Proj. 5-8  
Docket 70-364 pages  
PM: 7/25/60

Mallinckrodt's 7/8/60 proposed bridge  
for 8"  $U_2$  cylinders.

Adjacent ~~cylinders~~ spheres!

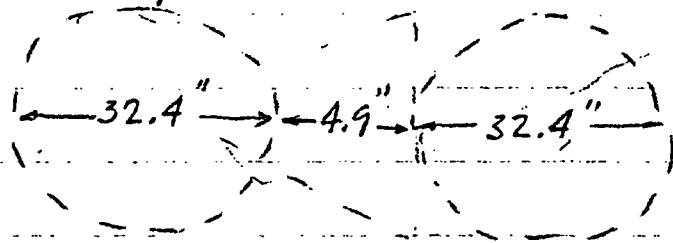
Mallinckrodt uses the cylindrical shape  
in determining  $\Omega$ , and comes out with  
values of 1.39 and 2.37 steradians. How-  
ever, item 3C(2) specifically says that  
interaction in this case is to be  
computed on the basis of the mass being  
contained in a spherical volume of  
 $H/U = 800$ .

$$\Omega = 2\pi(1 - \cos \theta); \quad \tan \theta = \frac{16.2}{16.2 + 4.9} = 0.767$$

$$\therefore \cos \theta = 0.793$$

$$\Omega = 2\pi(1 - 0.793) = 2\pi(0.207) = 1.3$$

Recalc. of  $\Omega$  using cylindrical geometry (Adjacent cylinders):

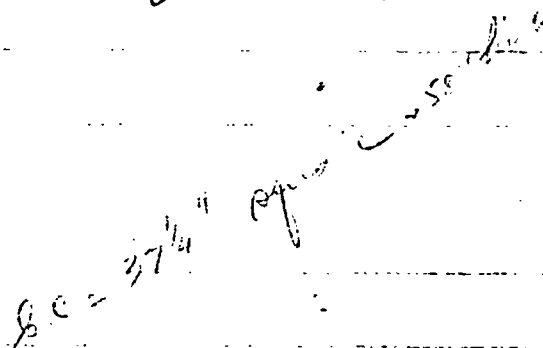
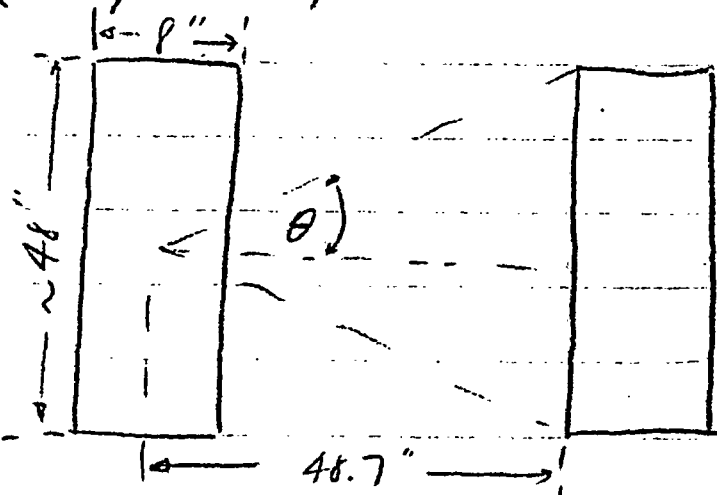
$$\tan \theta = \frac{24}{33.15}$$

$$\tan \theta = \frac{24}{48.7} = 0.493$$

(Diagonal cylinders):

$$\begin{aligned}\therefore \Omega &= 3(\text{adjacent cyls.}) + 2(\text{diagonal}) \\ &= 3(0.281) + 2(0.145) = 0.844 + 0.290 = 1.13\end{aligned}$$

(checks 1.39 steradians calc. by MCW fairly well, as they have also included very remote containers).
